## SUNDRY NOTICES AND REPORTS ON WELLS

7. If Unit or CA/Agreement, Name and/or No.  
891000303X1. Type of Well  
☐ Oil Well ☒ Gas Well ☐ Other8. Well Name and No.  
POKER LAKE UNIT 21 BD 122H2. Name of Operator  
XTO PERMIAN OPERATING LLCContact: KELLY KARDOS  
E-Mail: kelly\_kardos@xtoenergy.com9. API Well No.  
30-015-45696-00-X13a. Address  
6401 HOLIDAY HILL ROAD BLDG 5  
MIDLAND, TX 797073b. Phone No. (include area code)  
Ph: 432-620-437410. Field and Pool or Exploratory Area  
PURPLE SAGE-WOLFCAMP (GAS)

XTO Permian Operating, LLC requests permission to make the following changes to the original APD:

XTO Energy Inc.  
PLU 21 Brushy Draw 122H  
Projected TD: 21689' MD / 11239' TVD  
SHL: 452' FSL & 918' FWL, Section 21, T25S, R30E  
BHL: 200' FSL & 990' FWL, Section 33, T25S, R30E  
Eddy County, NM

11-3/4" x 8-5/8" x 5-1/2" 10M RSH-2 Wellhead  
Assembly, With T-EBS-F Tubing Head

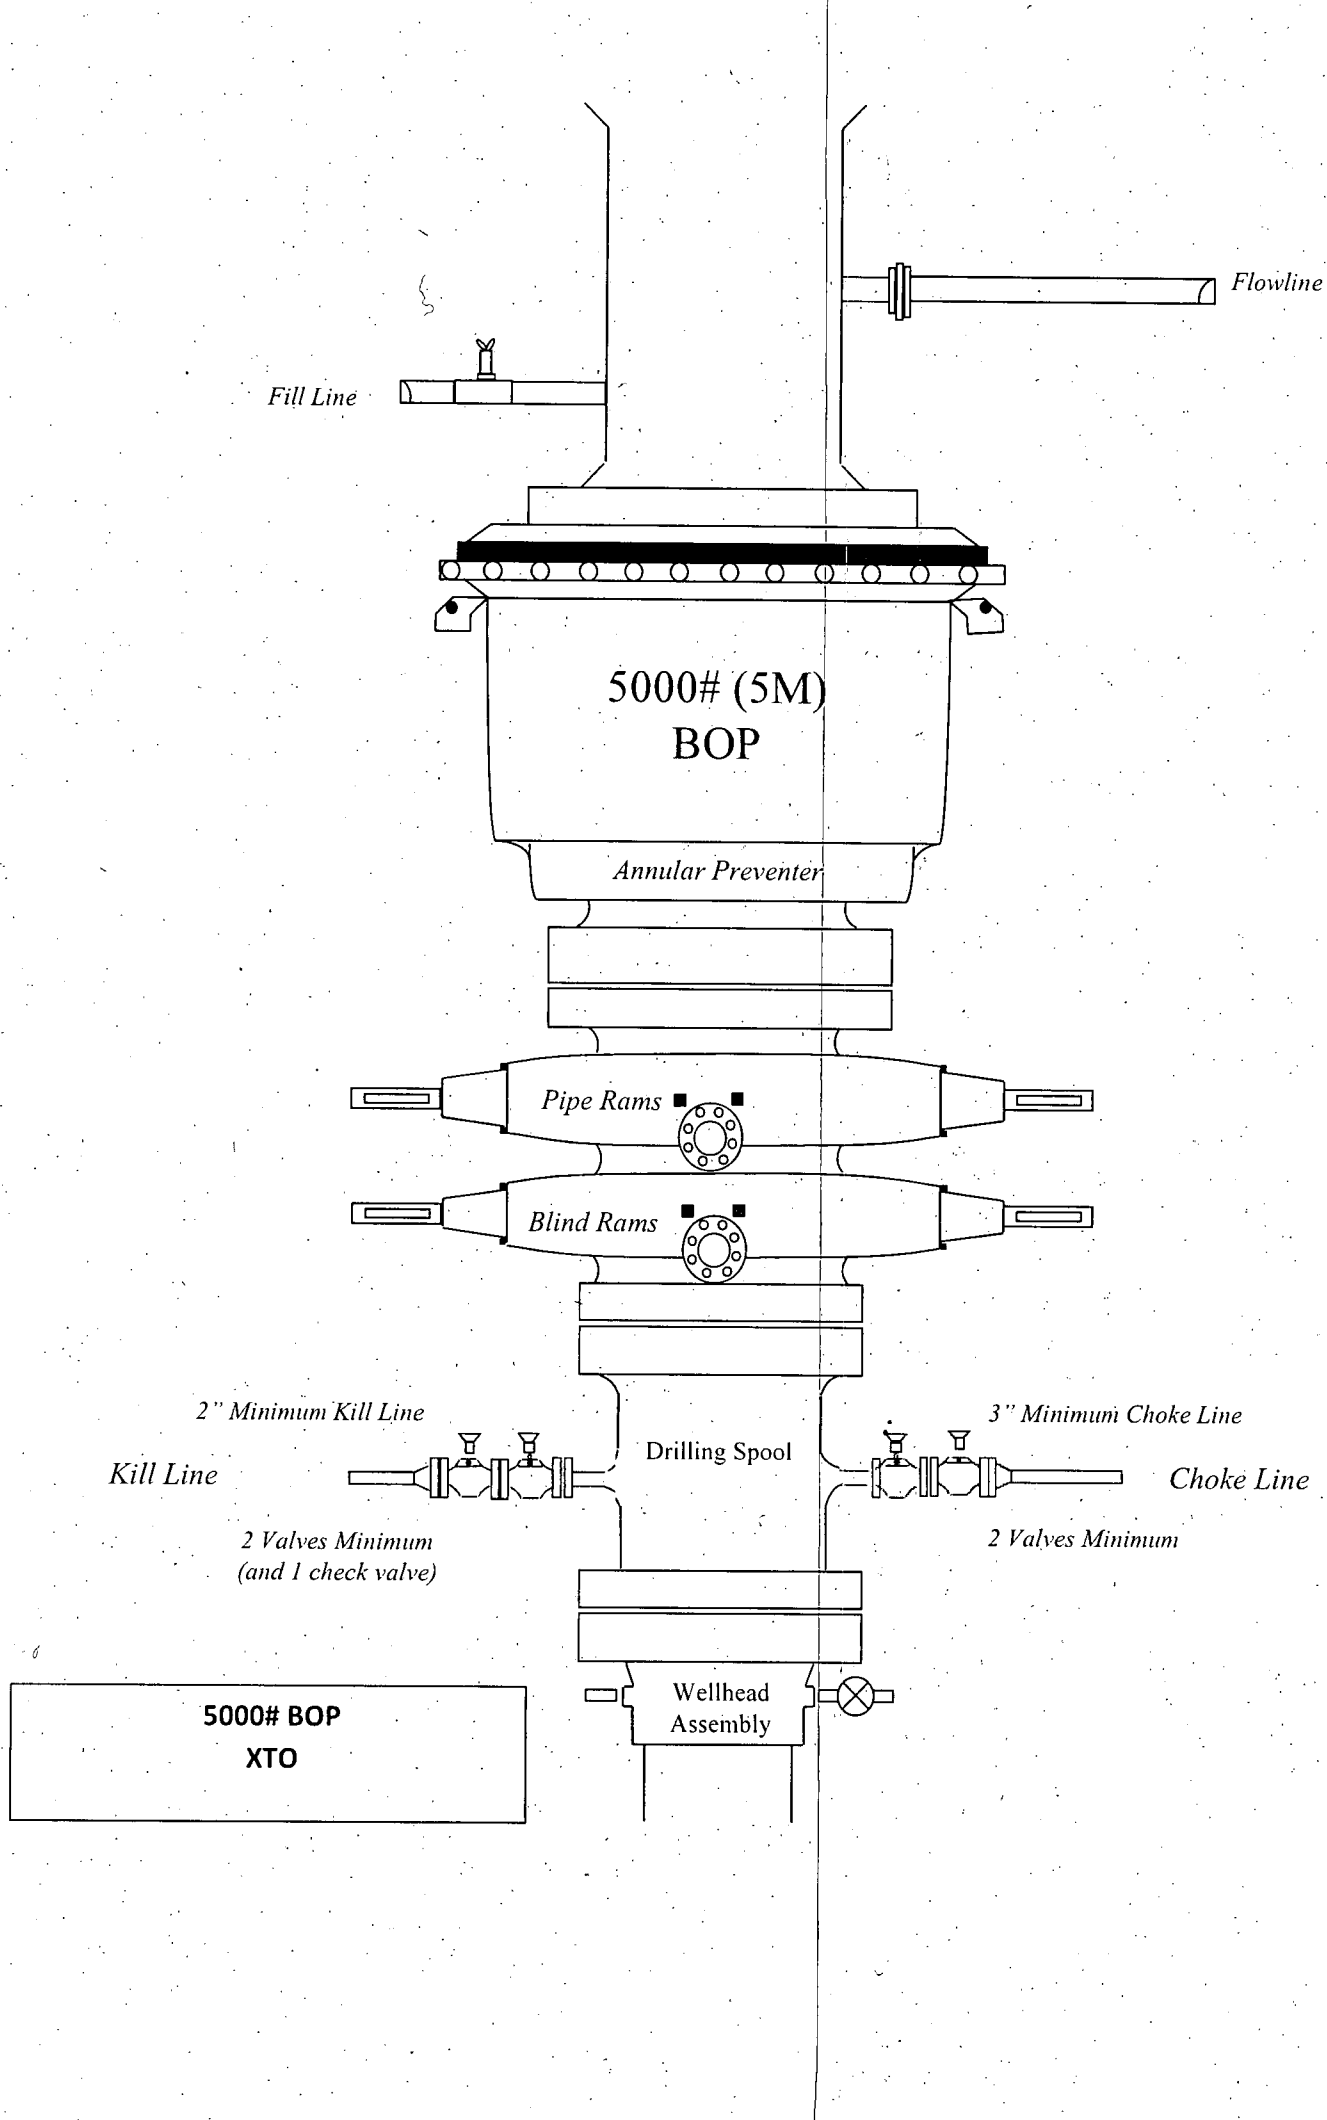
Permanent Wellhead - GE RSH Multibowl System

A. Starting Head (RSH System): 11-3/4" SOW bottom x 13-5/8" 5M top flange

B. Tubing Head: 13-5/8" 5M bottom flange x 7-1/16" 10M top flange

- Wellhead will be installed by manufacturer's representatives.
- Manufacturer will monitor welding process to ensure appropriate temperature of seal.
- Operator will test the 8-5/8" casing per Onshore Order 2.
- Wellhead manufacturer representative may not be present for BOP test plug installation

- a. Wellhead shall be installed by manufacturer's representatives, submit documentation with subsequent sundry.
  - b. If the welding is performed by a third party, the manufacturer's representative shall monitor the temperature to verify that it does not exceed the maximum temperature of the seal.

## GRADE D PRESSURE TEST CERTIFICATE

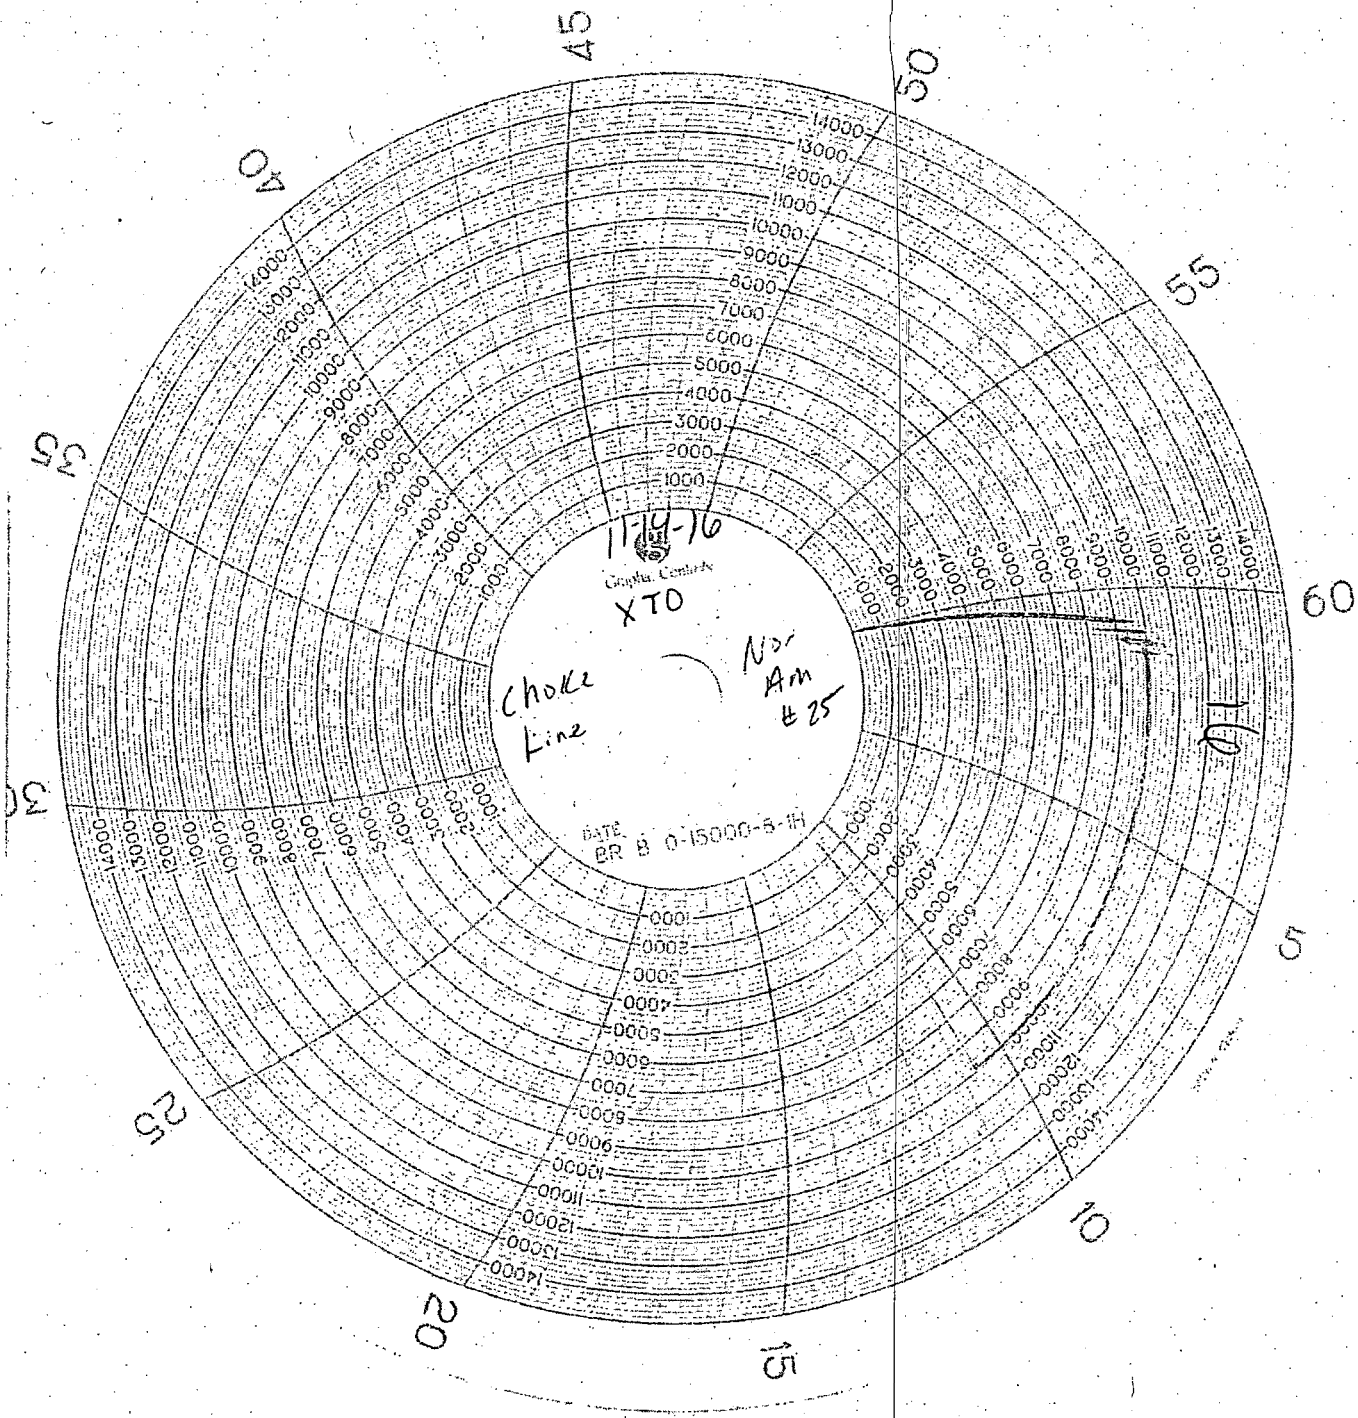
A variance is requested to allow use of a flex hose as the choke line from the BOP to the Choke Manifold. If this hose is used, a copy of the manufacturer's certification and pressure test chart will be kept on the rig. Attached is an example of a certification and pressure test chart. The manufacturer does not require anchors.

2. If a variance is approved for a flexible hose to be installed from the BOP to the choke manifold, the following requirements apply: The flex line must meet the requirements of API 16C. Check condition of flexible line from BOP to choke manifold, replace if exterior is damaged or if line fails test. Line to be as straight as possible with no hard bends and is to be anchored according to Manufacturer's requirements. The flexible hose can be exchanged with a hose of equal size and equal or greater pressure rating. Anchor requirements, specification sheet and hydrostatic pressure test certification matching the hose in service, to be onsite for review. These documents shall be posted in the company man's trailer and on the rig floor.
